Re: Border Winds Energy Project, Rolette County, North Dakota
Case No. PU-08-797

In the matter of the Siting Application of
Sequoia Energy US Inc. for the 150 MW Border
Winds Energy Project, Rolette County, North
Dakota

**PETITION FOR MODIFICATION OR
AMENDMENT OF FINDINGS OF FACT,
CONCLUSIONS OF LAW, AND ORDER
GRANTING CERTIFICATE OF SITE
COMPATIBILITY**

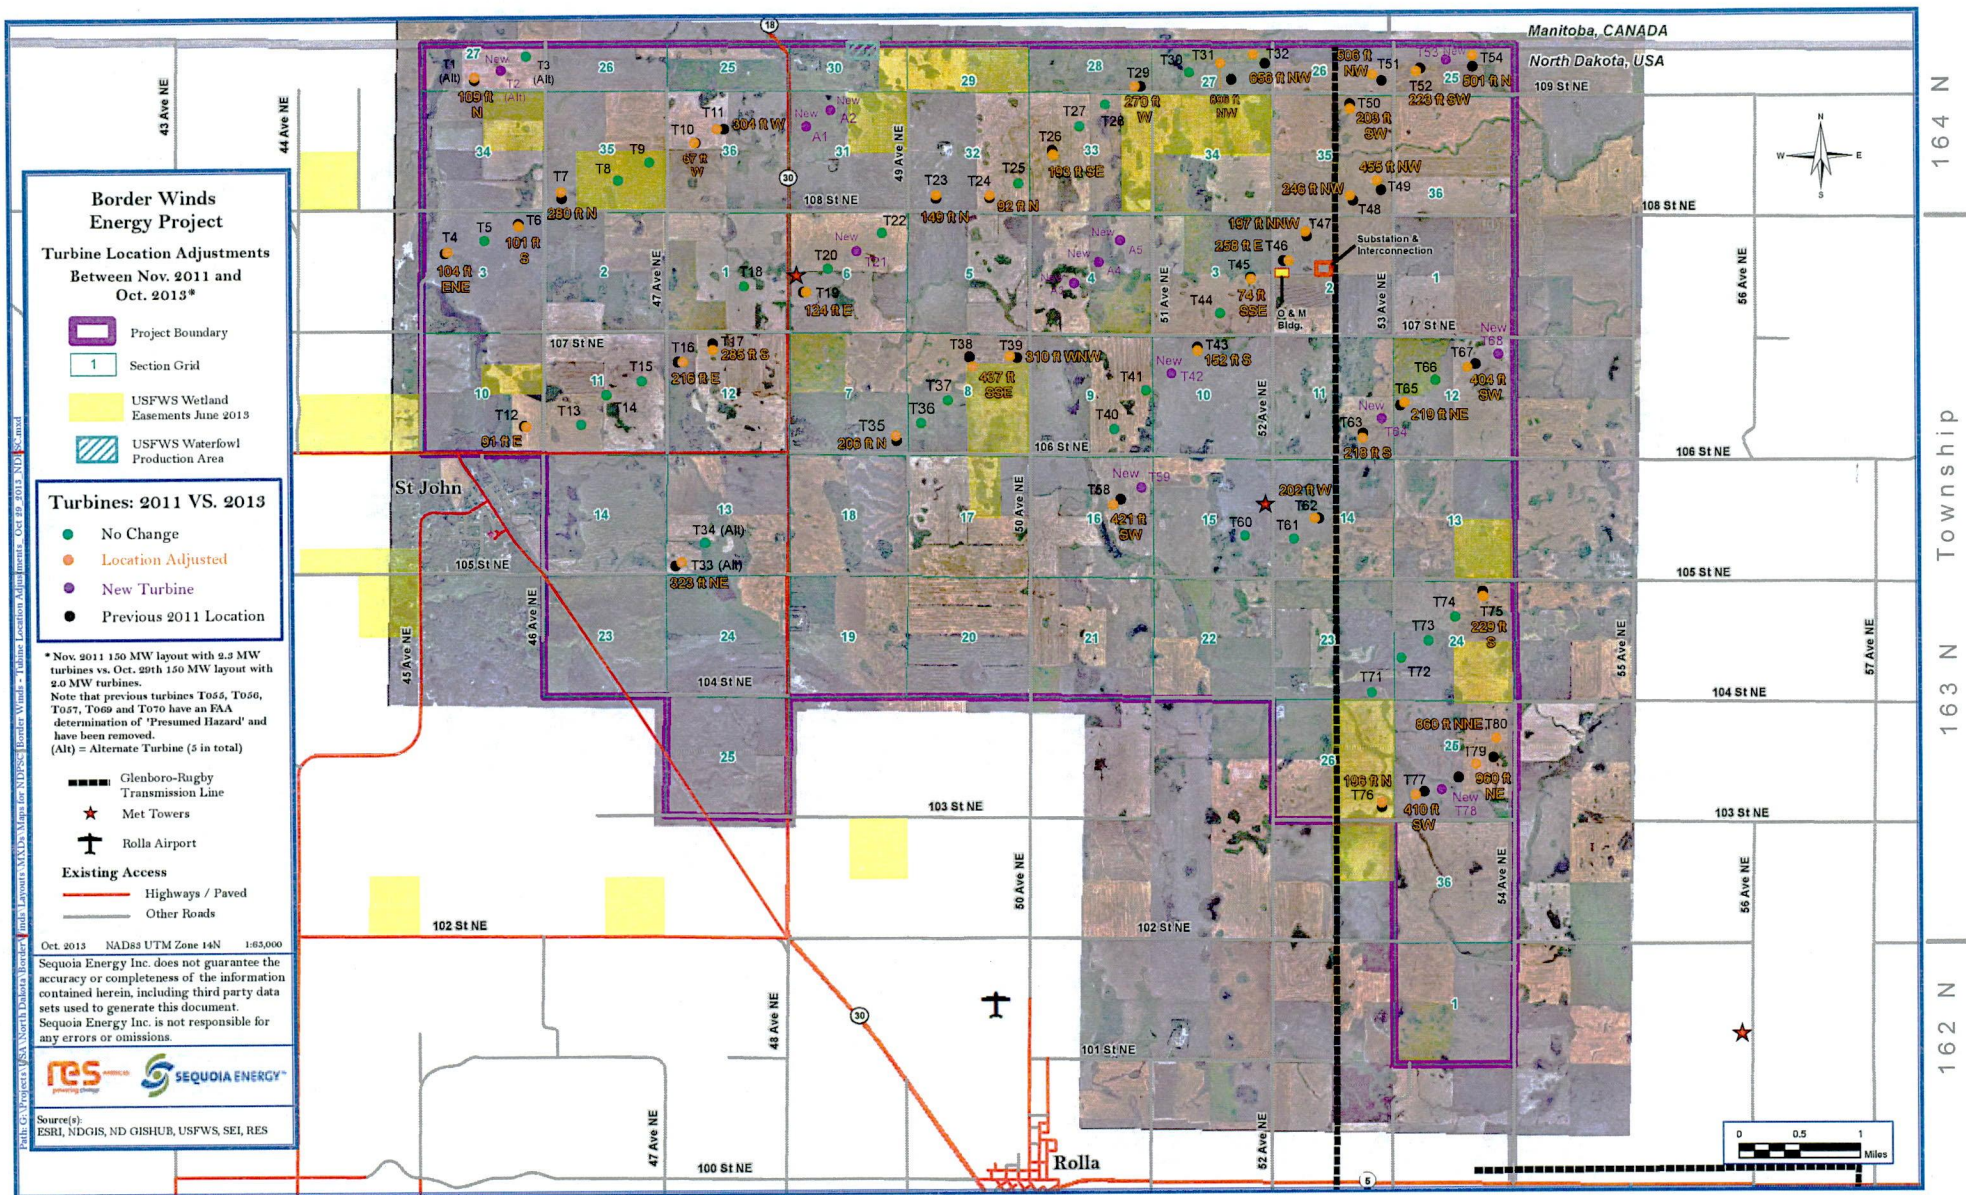
As specified in Paragraphs 1 and 8 of the Findings of Fact in the Order, the Project was to consist of up to sixty-six Siemens 2.3 MW wind turbines totaling approximately 150 MW of generating capacity, and each such turbine was to have an 80 meter (262.5 foot) hub height and a 101 meter (331.4 foot) rotor diameter. Border Winds Energy has now identified a different wind turbine generator for the Project: the Vestas V100 2.0 MW wind turbine generator on 95 meter (311.7 foot) towers with a rotor diameter of 100 meter (328.1 feet). The Vestas V100 begins operations at wind speeds of 3 meters per second and reach a rated capacity of 2.0 MW at 16 meters per second. To maintain appropriate turbine spacing and other setbacks, this change in the wind turbine generator also requires revision to the turbine layout. The revised turbine layout is included as Attachment 1.

Because the revised turbine layout is located entirely within the Project boundary previously studied for potential human and environmental impacts and because the Project will comply with all setbacks and layout restrictions in the Order and Company Certification, the proposed amendment will not result in any impacts to resources not already considered by the Commission. Additionally, all pre-construction and construction survey, reporting, and administrative compliance obligations set forth in the Order and the Company Certification remain unchanged by the proposed amendment and will be met by Border Winds Energy.⁸ Consequently, the Project will continue to meet regulatory criteria and be compatible with the Order.
